## HISTORIC AND DESIGN REVIEW COMMISSION

Agenda Item No: 25

**HDRC CASE NO:** 2016-227  
**ADDRESS:** 319 BARRERA  
**LEGAL DESCRIPTION:** NCB 714 BLK 11 LOT S 102.6 FT OF 5 & W 2.8 FT OF 6  
**ZONING:** RM4 H  
**CITY COUNCIL DIST.:** 1  
**DISTRICT:** Lavaca Historic District  
**APPLICANT:** Ignacio Salas-Humara  
**OWNER:** Juan Pablo Fernandez  
**TYPE OF WORK:** Rehabilitation and addition to an existing accessory structure  
**REQUEST:**

Historic and Design Review Commission  
Design Review Committee  
Report & Recommendation

**Proposed Remodel Garage**  
1/8" Scale

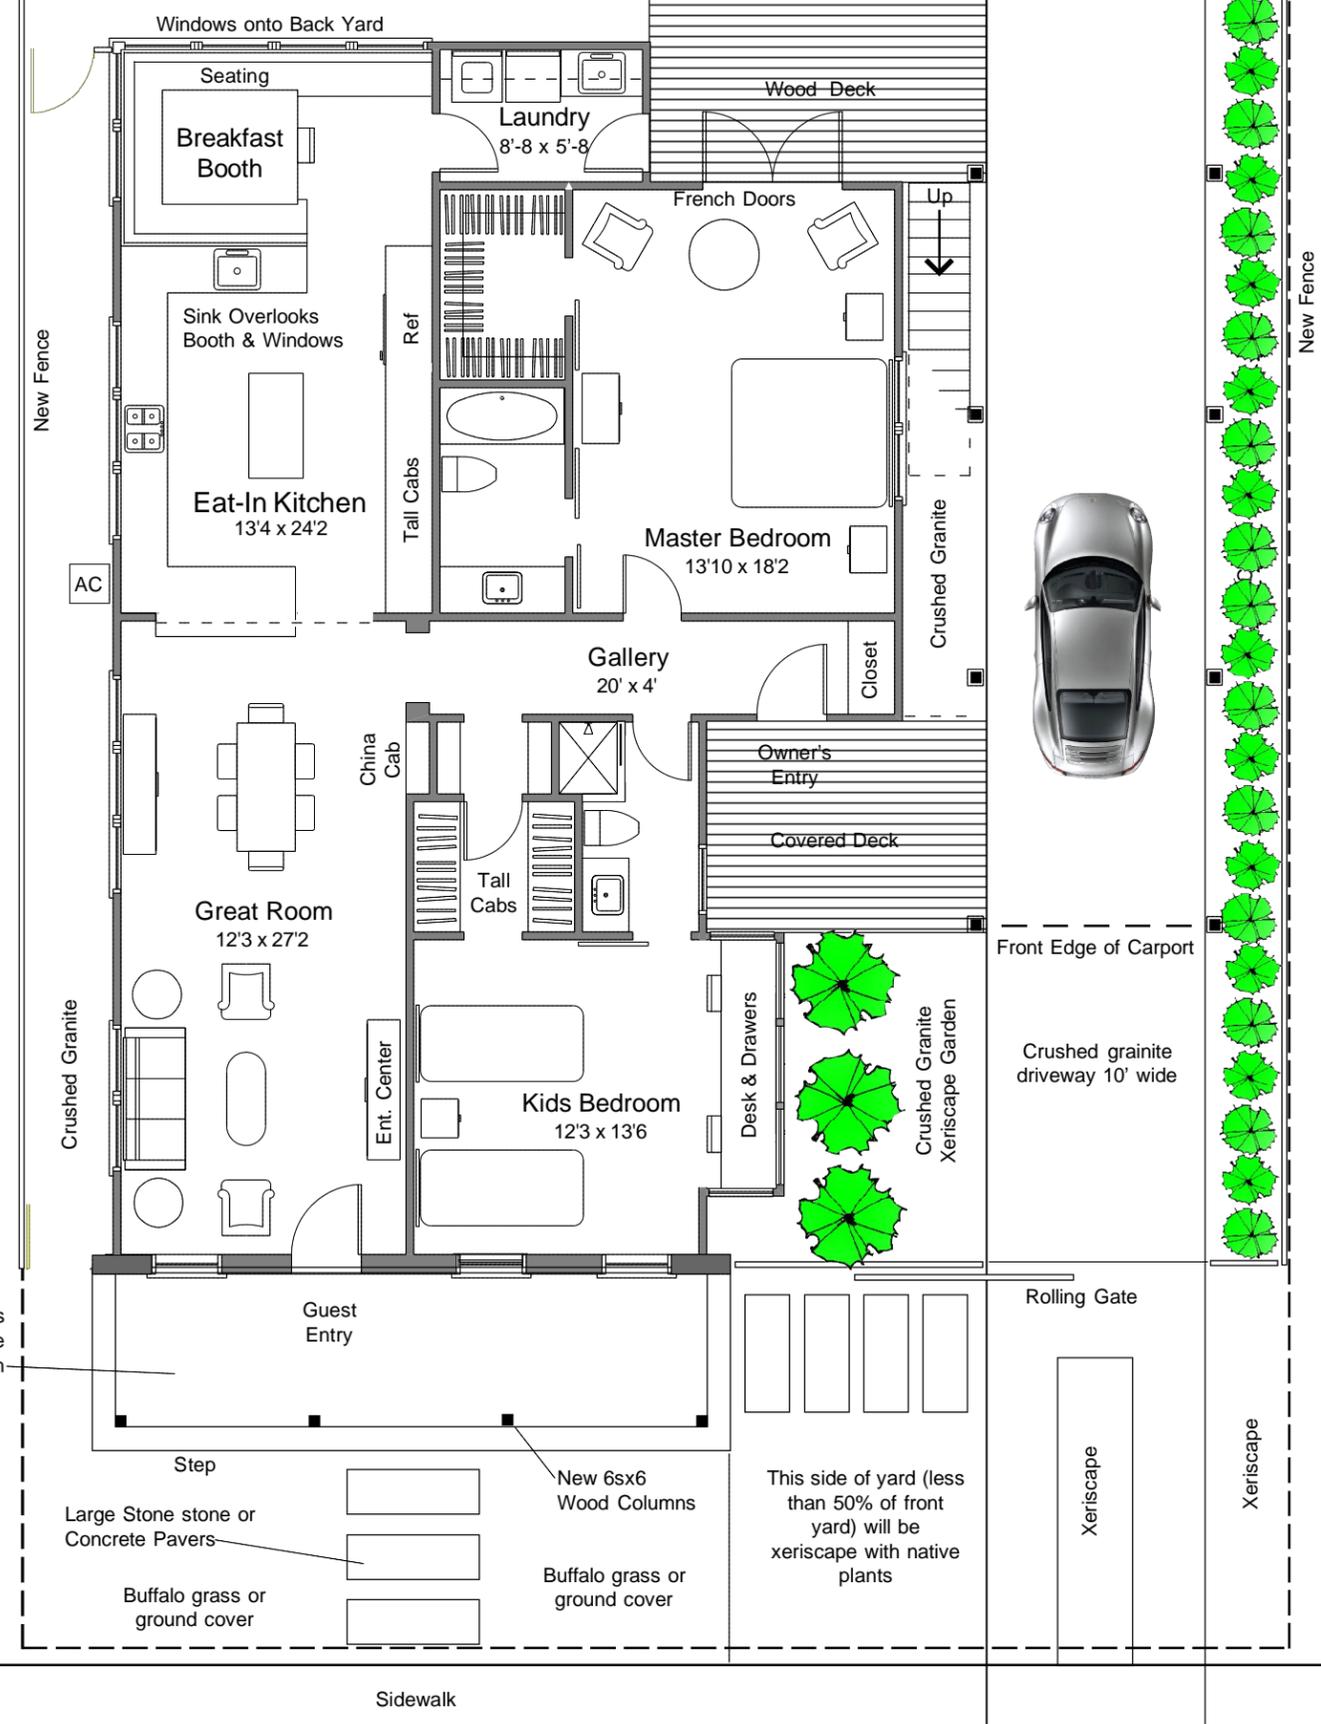
- j. ADDITION – ACCESSORY – At the rear of the primary historic structure on the east side of the lot, the applicant has proposed to construct a second story addition to the existing accessory structure. According to the Guidelines for Additions 1.A., additions should be designed in keeping with the historic context of the block. Additionally, according to the Guidelines for Additions 1.B., additions should be subordinate to the principle facade of the original structure in terms of their scale and mass. The applicant has proposed a two story metal clad accessory structure to the rear (east) of a single story historic structure. Staff finds the applicant’s proposal inappropriate and inconsistent with the Guidelines.

## Proposed Street Elevation

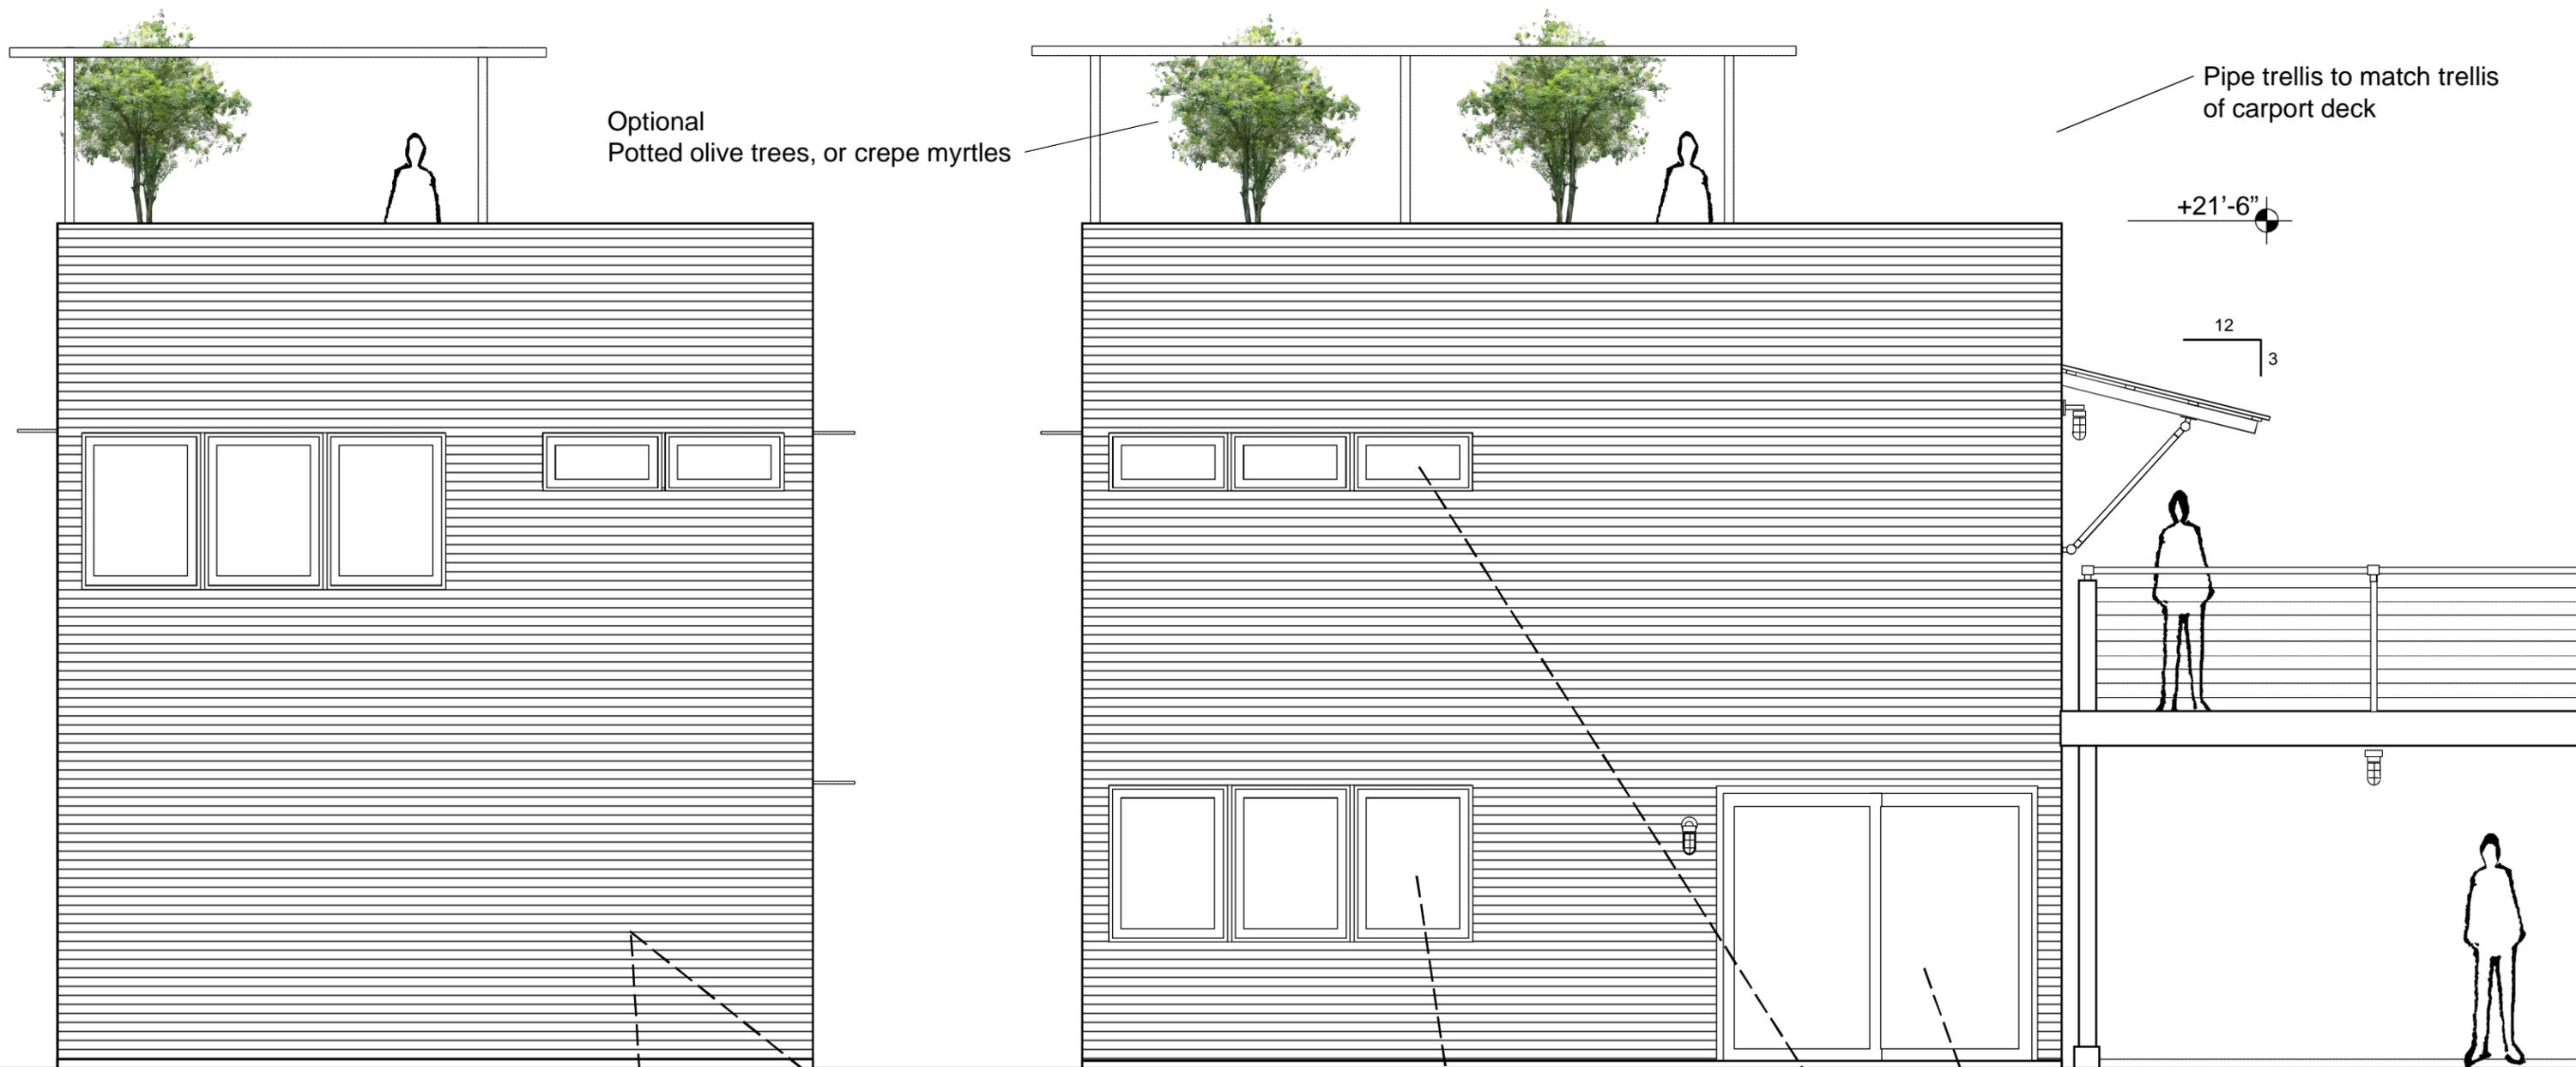
- g. PORCH MODIFICATIONS – The applicant has proposed to reconfigure the roof of the front porch roof to be complete separate from that of the side gable; this would result in a side gable with a front shed. The separation of those two roof forms is appropriate, however, the front facing roof form should feature a pyramidal or tapered hipped form, similar to the roof forms found at 315 Barrera, 305 Barrera and 301 Barrera. Staff recommends the applicant incorporate a similar, architecturally appropriate roof form into the proposed design at 315 Barrera.

- p. **FENCING** – The applicant has proposed to replace the existing side yard chain link fence with a new perforated corten fence and gate. According to the Guidelines for Site Elements 2.B.v., new fences should be constructed of materials found historically throughout the district. Staff finds that a corten fence is not appropriate, however, a contemporary interpretation of a wrought iron fence may be appropriate.

The fence feels heavy in massing.

- i. That the applicant propose siding that is complementary of the historic structure for the existing additions.
- ii. That the applicant introduce columns appropriate for a Folk Victorian house.
- iii. That the applicant reduce the overall massing of the proposed accessory structure’s addition.
- iv. That the applicant remove the proposed pipe trellis structure from the carport to reduce its overall mass.
- v. That the applicant include windows that are consistent with the Historic Design Guidelines, Window Policy Document.
- vi. That the the applicant maintain all front yard grass and xeriscape behind the front façade of the house.

## Proposed Remodel Garage

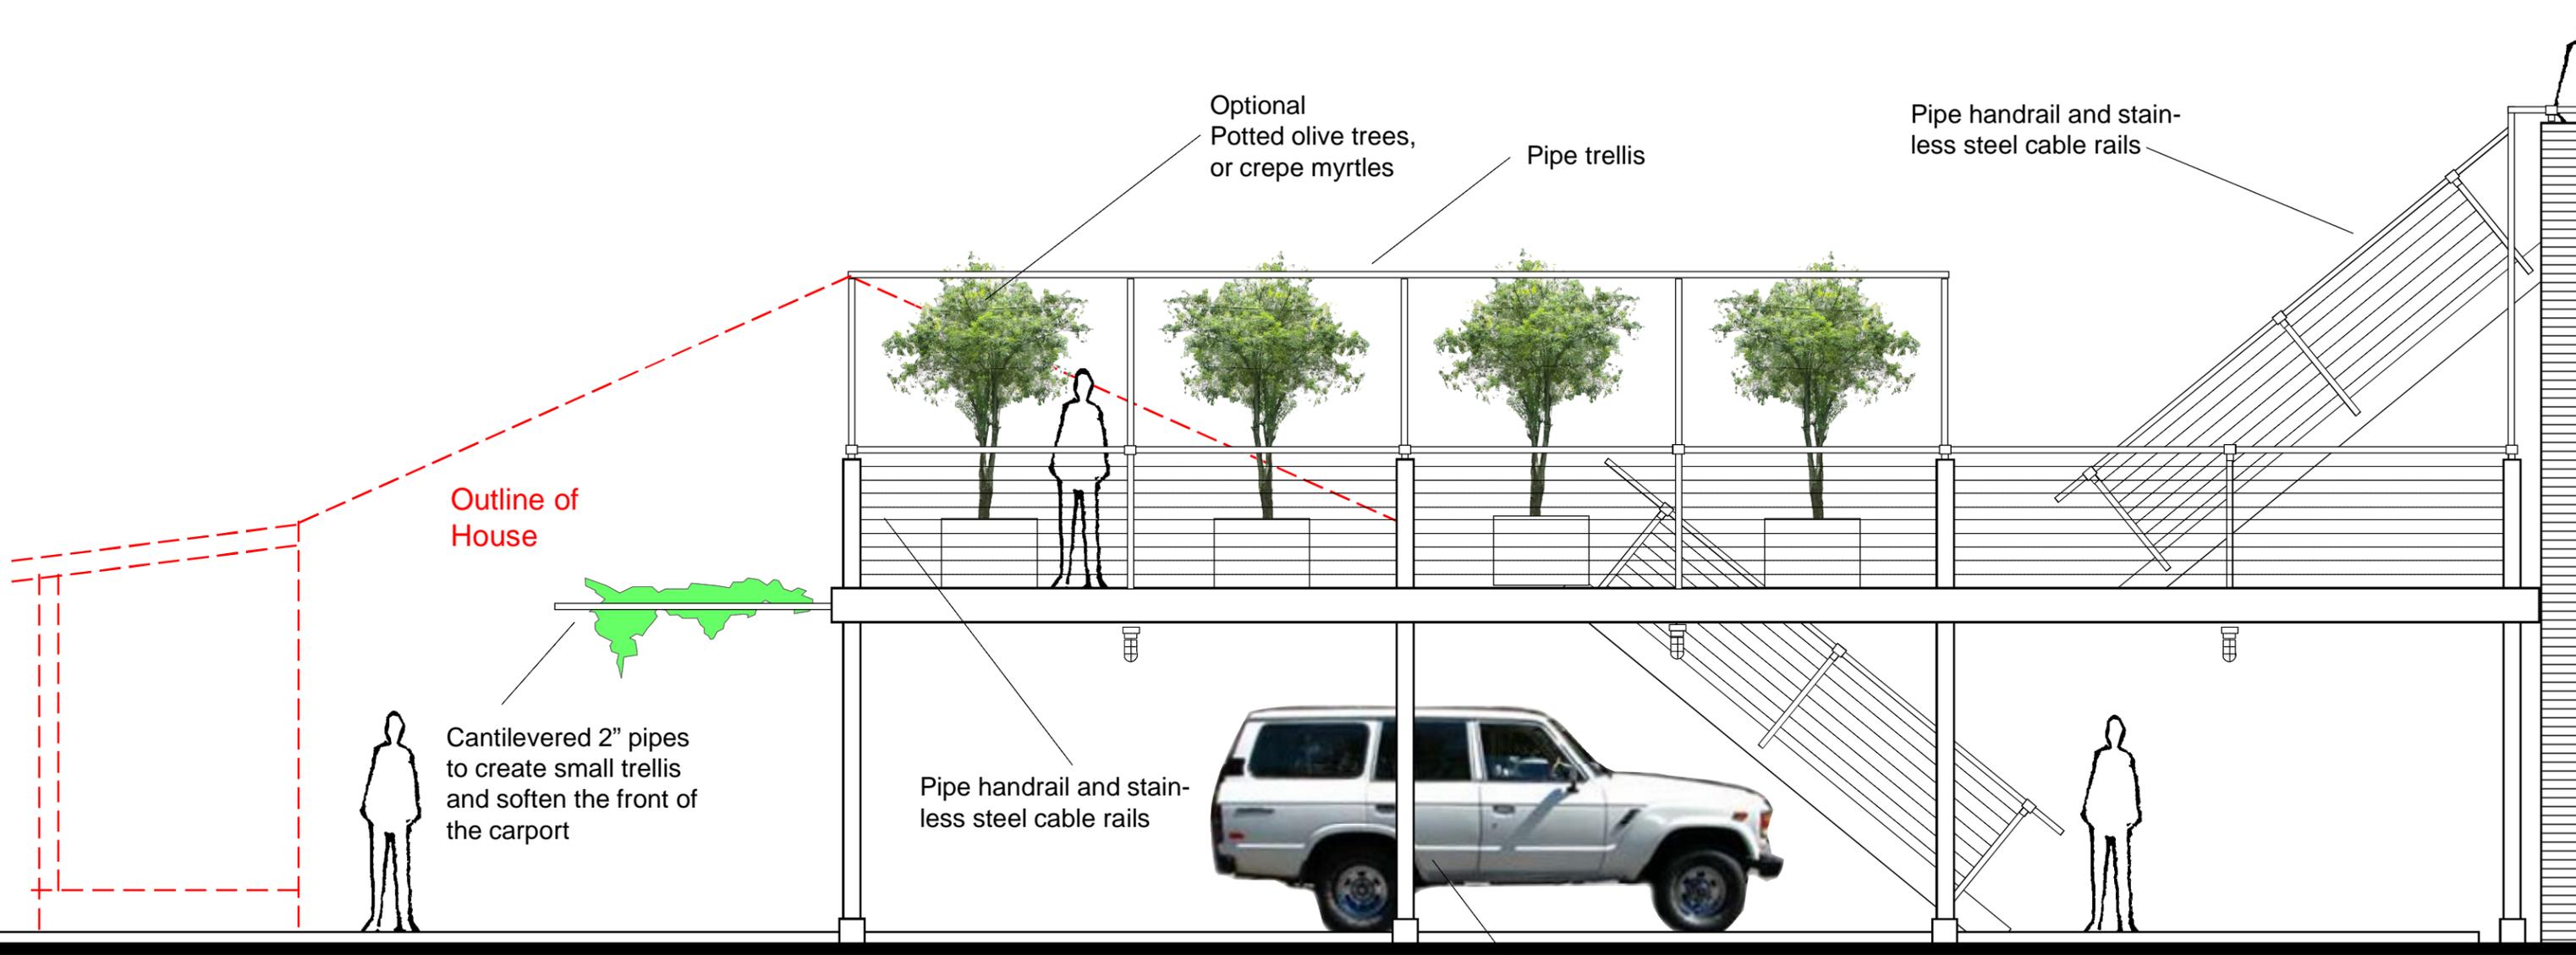
- k. ADDITION – ACCESSORY – In regards to height, additions should be consistent in height with the primary historic structure. The applicant has proposed an overall height of 21’ – 6” with an additional 10’ of trellis structure for the accessory structure’s addition. The overall height of the primary historic structure is approximately fifteen (15) feet in height. The applicant has provided a line of sight diagram which notes that the proposed addition to the accessory structure will not be seen from the public right of way on Barrera; however, the accessory structure is not immediately to the rear of the primary historic structure and will be visible from the public right of way.

- l. ADDITION – ACCESSORY – In regards to materials, the applicant has proposed materials which include solid, corrugated and perforated corten siding, a metal canopy and a metal trellis structure. Staff finds that these materials may be appropriate is properly dimensioned to complement the traditional siding dimensions found throughout the Lavaca Historic District. Staff finds that the applicant should include windows that are consistent

- m. **ADDITION – ACCESSORY** – Architecturally, the applicant has proposed an addition to the existing accessory structure that provides little façade separation and does not provide a clear contemporary interpretation to relate it to the primary historic structure on the lot or other structures located in the Lavaca Historic District. Staff finds that modified roof forms, such as a shed roof or partial hipped roof or a partial split level plan featuring a shed roof with a similar profile as the street facing slope of the historic structure’s side gable roof may not only reduce the massing of the proposed structure, but also provide an appropriate contemporary interpretation.

BF: concerns about 3 story building  
Wants to see a stronger case what's proposed  
Concerns with patio elements falling  
Not an appropriate design for historic district  
Suggested come back with some changes, ~~before~~  
coming back

**PROPOSED 6X6 WOOD PORCH POSTS**

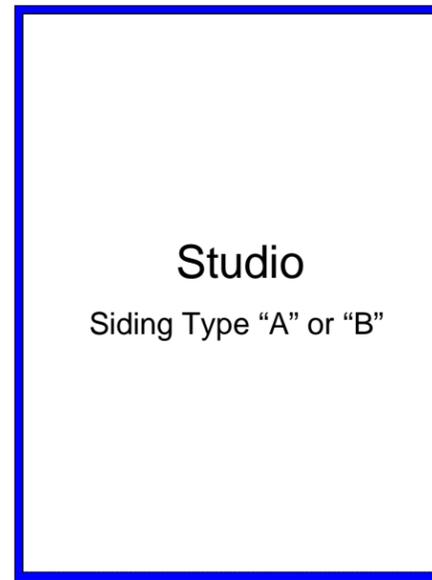
- f. PORCH MODIFICATIONS – The applicant has proposed to remove the existing wrought iron railings, security bars, floor tile and columns currently existing on the front façade. The applicant has proposed to install cedar 6x6 columns to replace the existing wrought iron columns. The removal of the existing wrought iron elements and floor tile are appropriate, however, the applicant’s proposal of a simple square column is not appropriate for a Folk Victorian style house. Staff recommends the applicant propose a column design that is architecturally appropriate.
